FINAL ENVIRONMENTAL IMPACT STATEMENT

By the New York State Department of Environmental Conservation

It's Greener Now, Inc. – Padua Gravel Pit

Article 23, Mined Land Reclamation, DEC #8-4424-00006/00001 (MLR#80244)

DATE: 4/13/2018 | SCALE: 1"=125' | DWG. NO. 16157005A | PLATE 5 OF 9

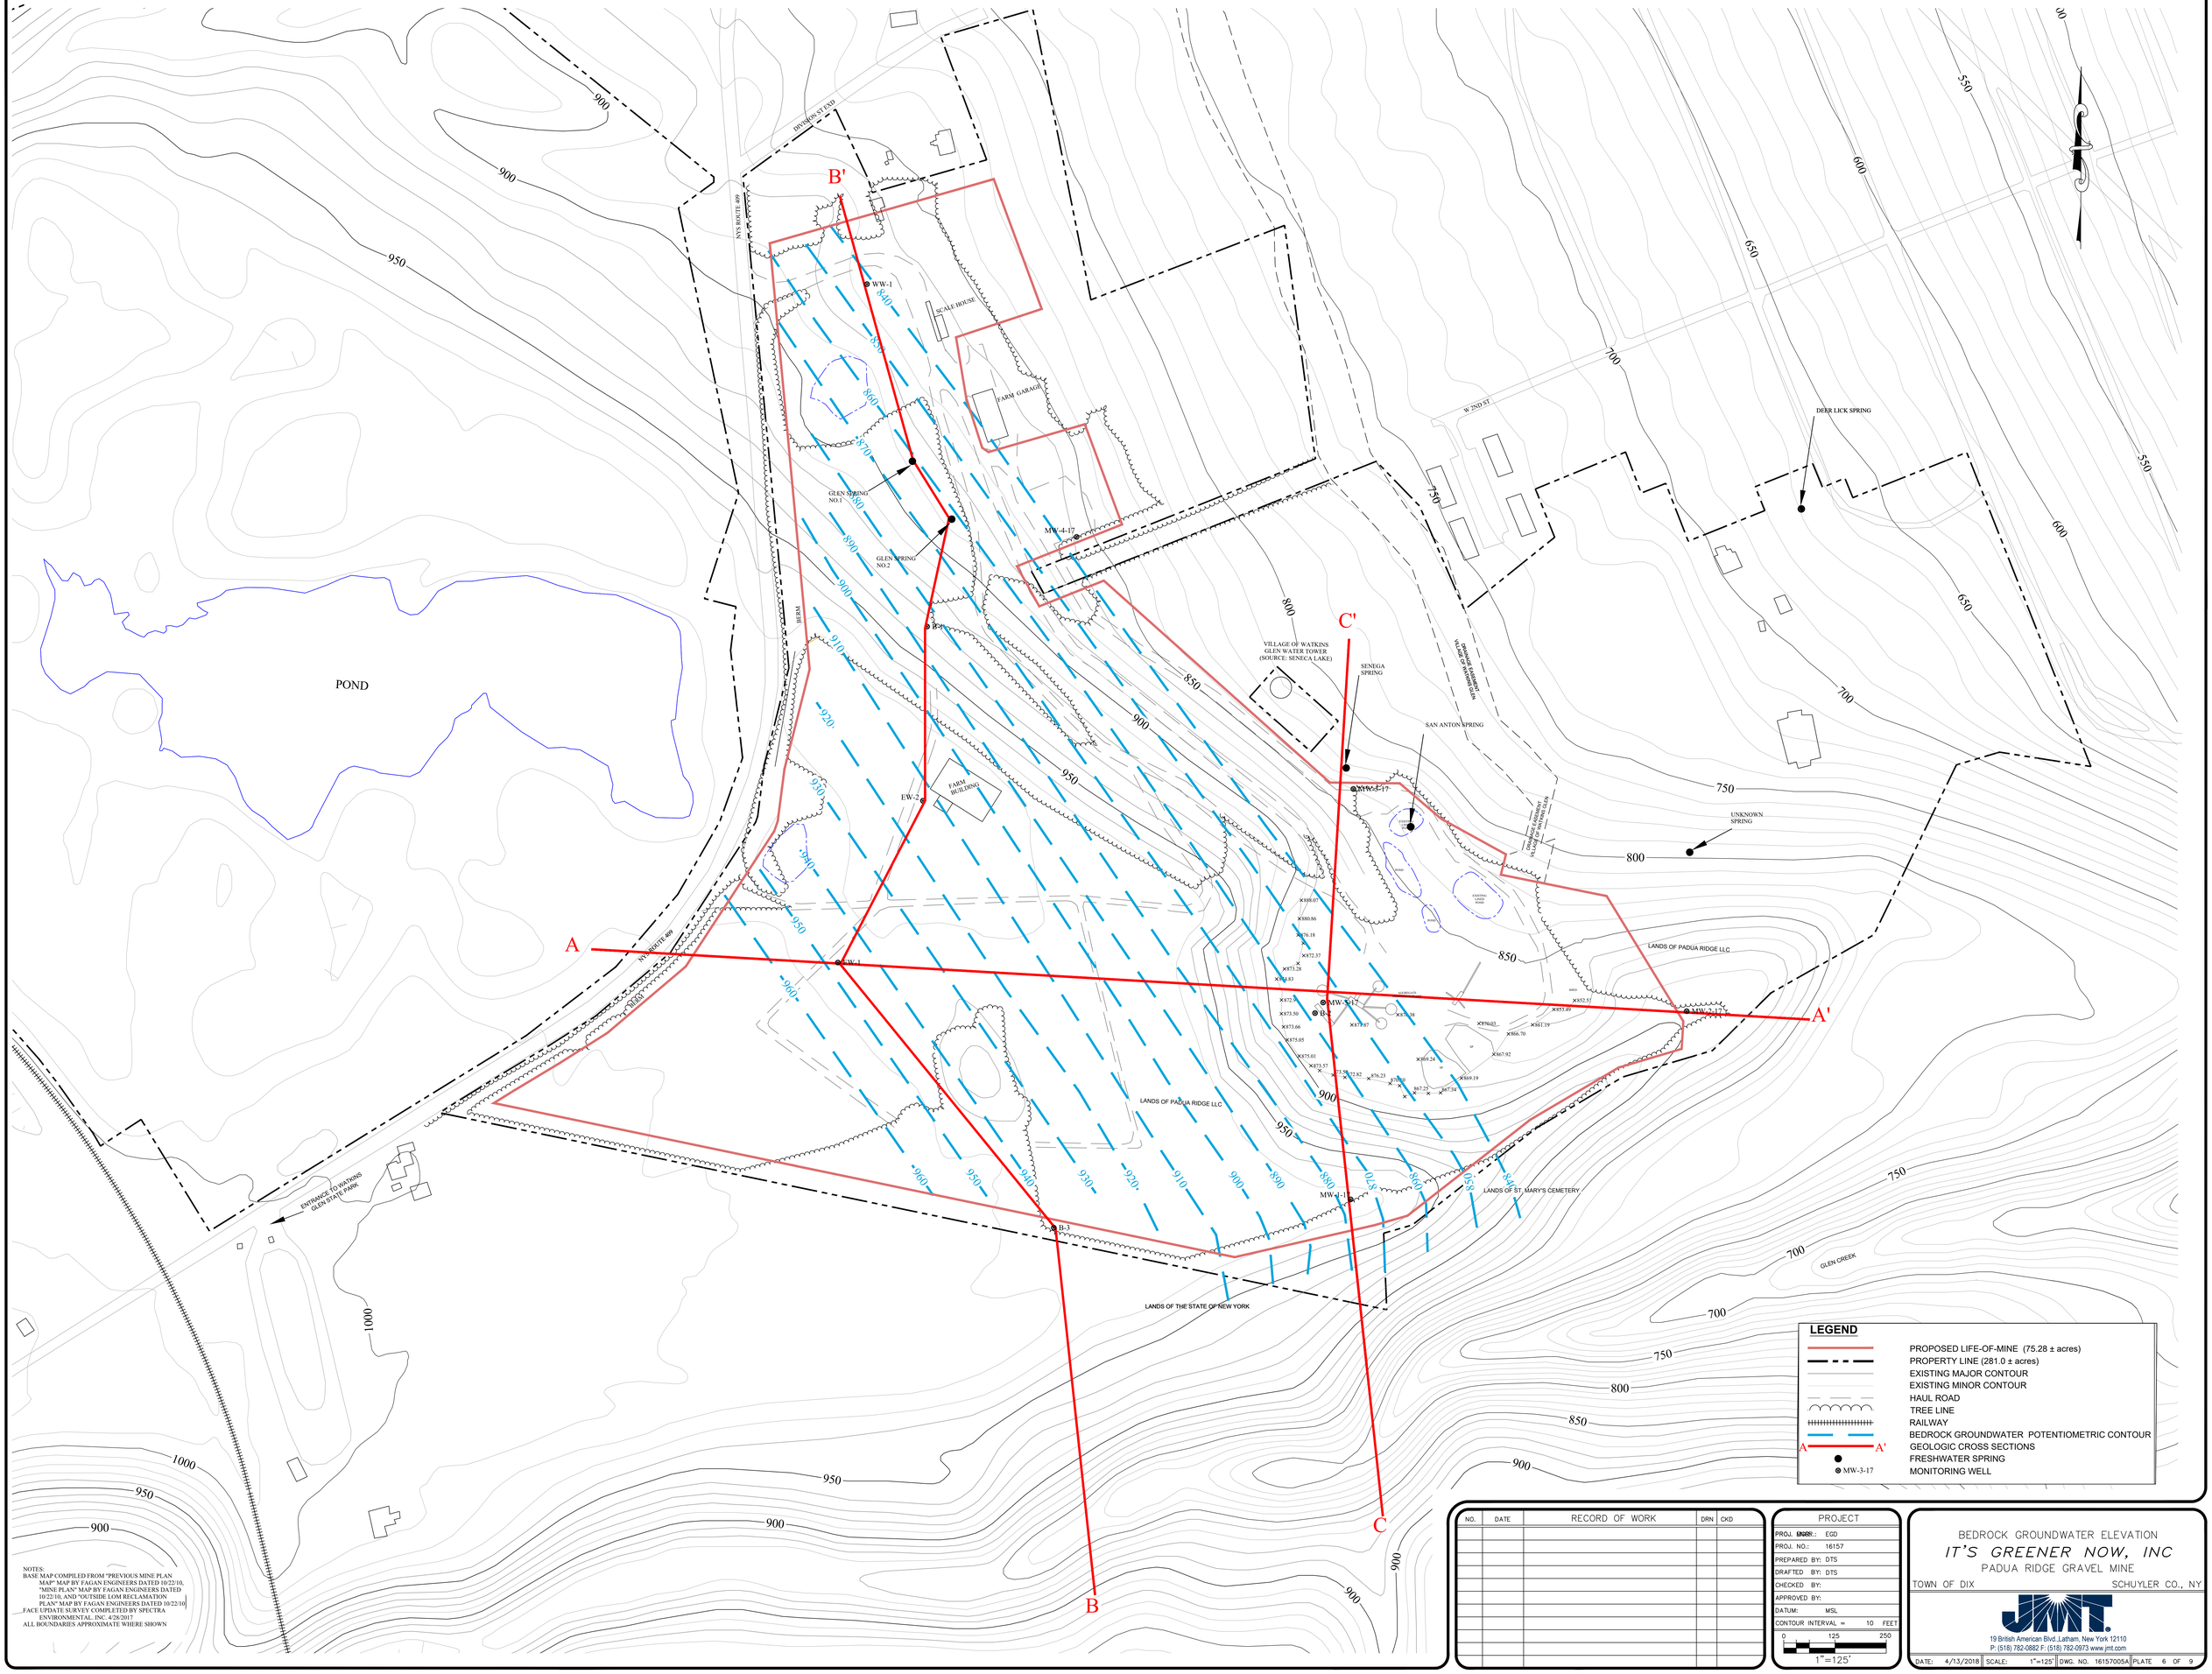
OPRHP Comment 18: *The overburden groundwater contour lines on Plate 5 should be dashed the same as the bedrock groundwater contour lines are on Plate 6, due to the very limited number of data points. Also, the lines should not extend beyond the IGN property line as a regional study was not completed as part of this DEIS and the groundwater contours are interpolated.*

DATE: 4/13/2018 | SCALE: AS SHOWN | DWG. NO. 16157005C | PLATE 7 OF 9

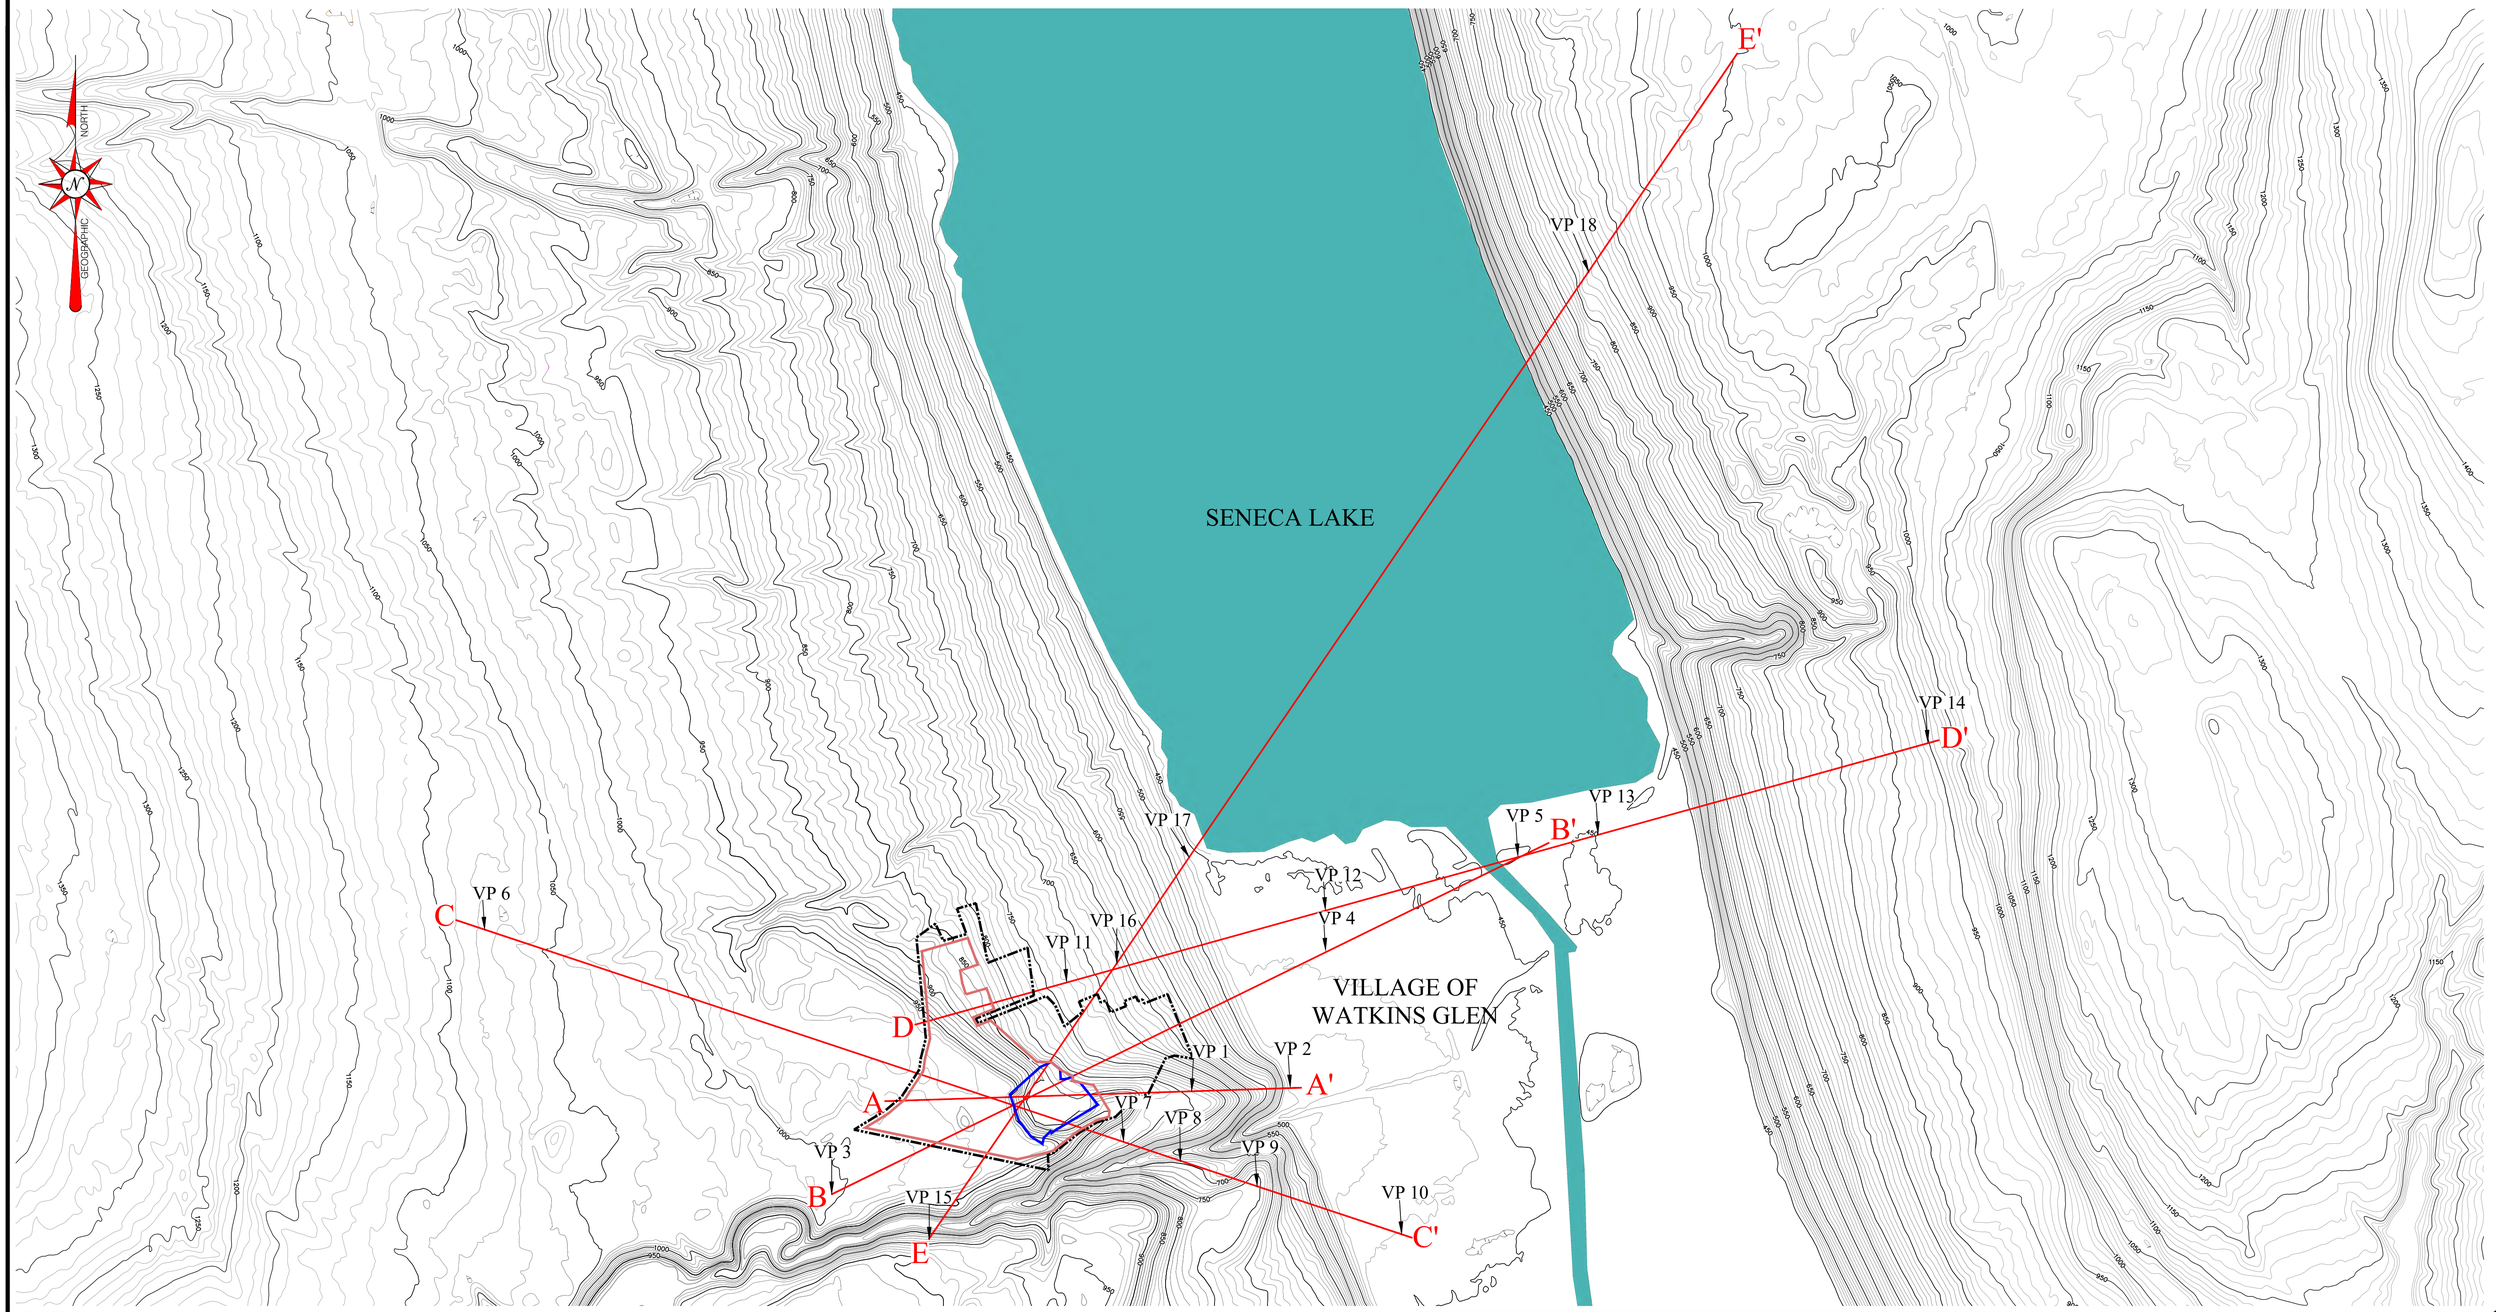
Response: The location of MW-2-17 on cross-section C-C' is a plot error and does not represent the location of the monitoring well. The final EIS will omit MW-2-17 from cross-section C-C'. See Plate 7 of 9 in Attachment C for the reflected change.

Response: The final EIS will reflect this requested change. See Plate 7 of 9 in Attachment C for the reflected change.

Response: The comment refers to a print issue within the version reviewed; the final EIS will remove the thin black line on the C-C' cross-section, as it was inadvertently shown. See Plate 7 of 9 in Attachment C for the reflected change.

DATE: 4/13/2018 | SCALE: 1"=125' | DWG. NO. 1615700.3E | PLATE 1 OF 3

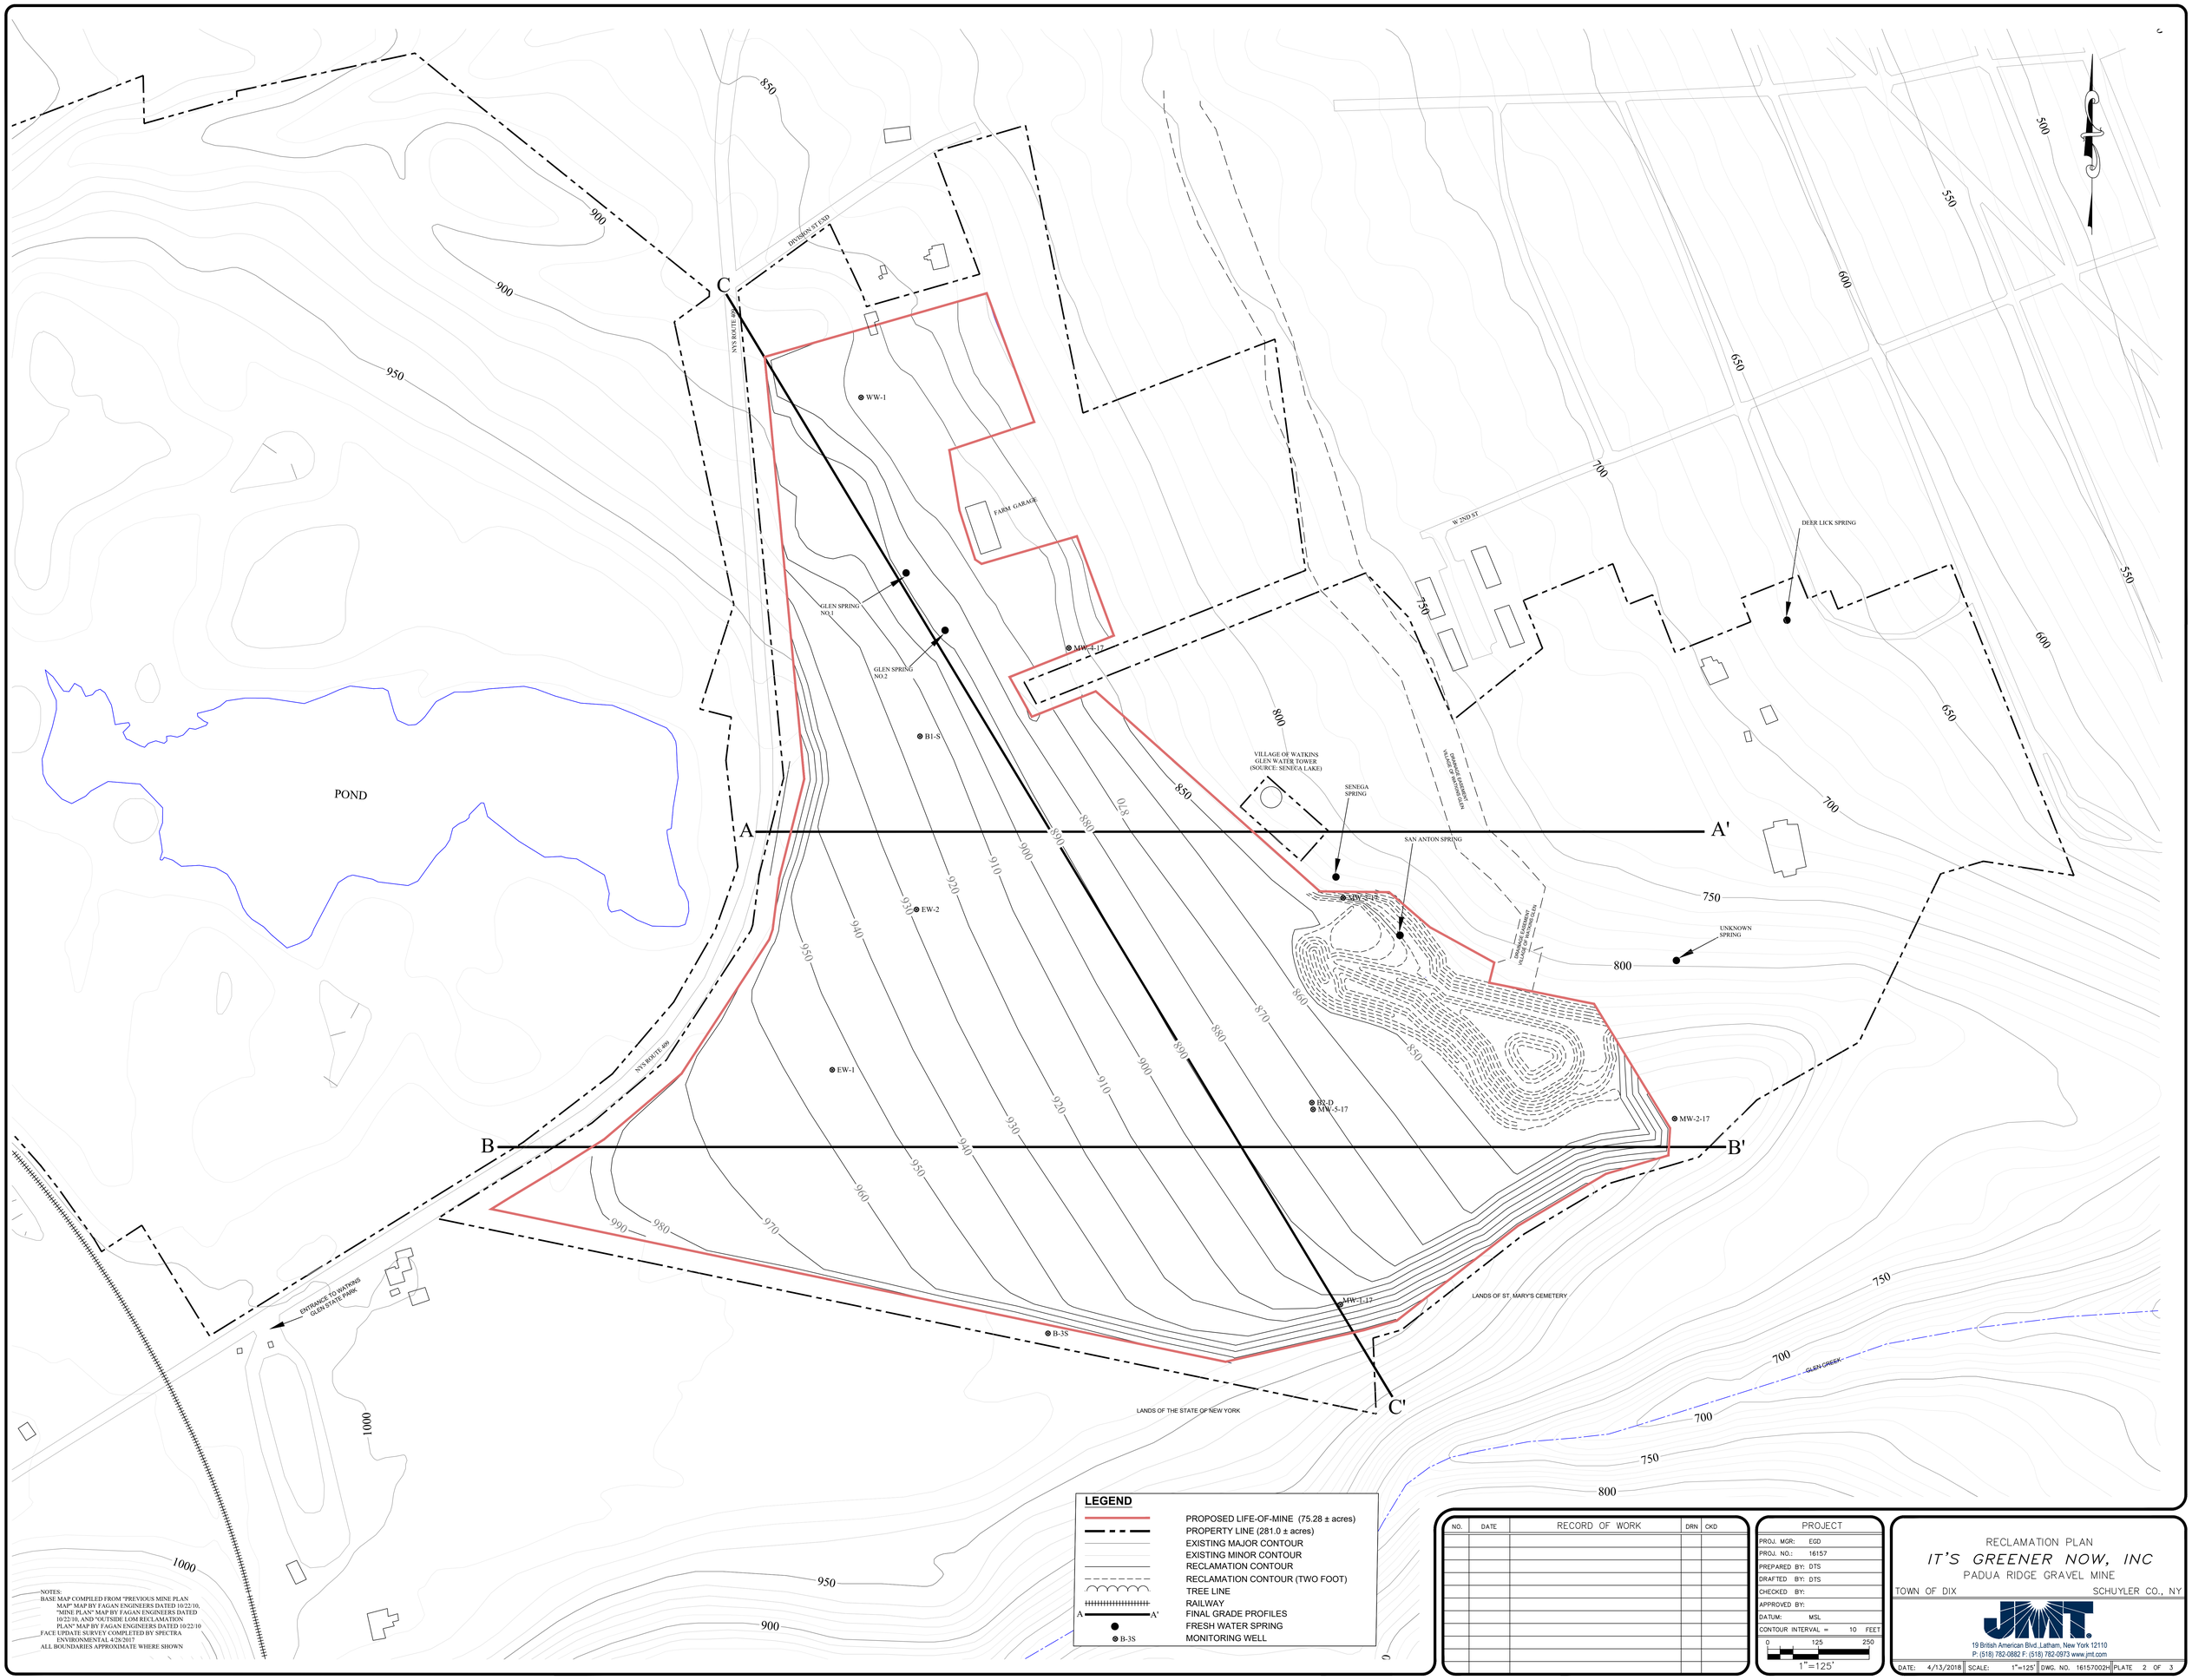
Response: There are no new ingresses, egresses, or truck loading areas proposed as part of the mine expansion. Facility operations will also remain the same. See Mine Plan Map (Plate 1 of 3) included in the MLUP (DEIS, Appendix F) for facility layout details.
